**IN THE DRAWINGS**

### **REMARKS**

In the Office Action dated May 19, 2006, the Examiner objected to the specification as containing new matter, noted an inconsistency between FIG. 3 in the provisional application and FIG. 3 as filed, along with the description of FIG. 3, rejected claims 1-7 for lack of enablement, rejected claims 1-7 for failure to comply with the written description requirement, rejected claims 12-18, 21 and 22 for failing to particularly point out and distinctly claim the subject matter which Applicant regards as the invention. The Examiner further rejected claims 1-5, 12, 17 18, 21, 22, 36, 37, 39 and 50 as being anticipated by the prior art. Applicants provide the following remarks.

Figure 3

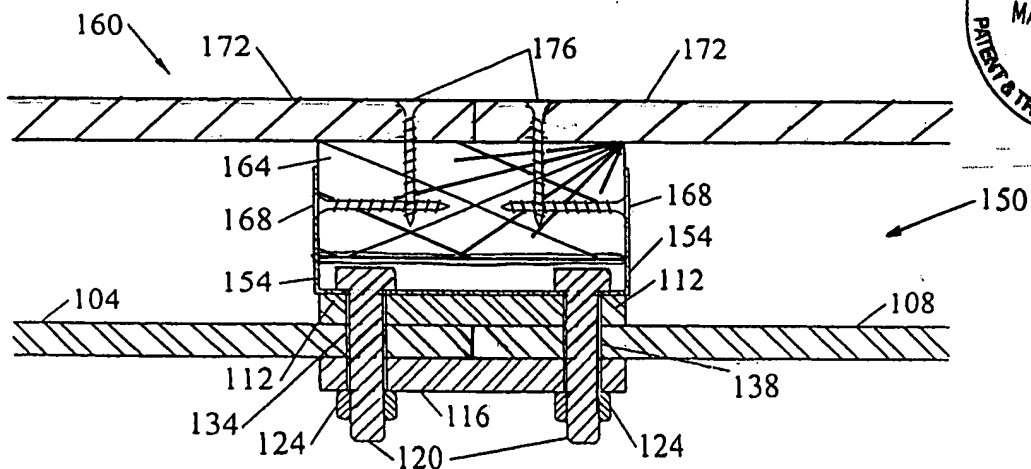
With respect to FIG. 3, Applicant has amended the figure to show a small space between the bolts and the two-by-four.

Please replace FIG. 3 previously filed with the enclosed FIG. 3.
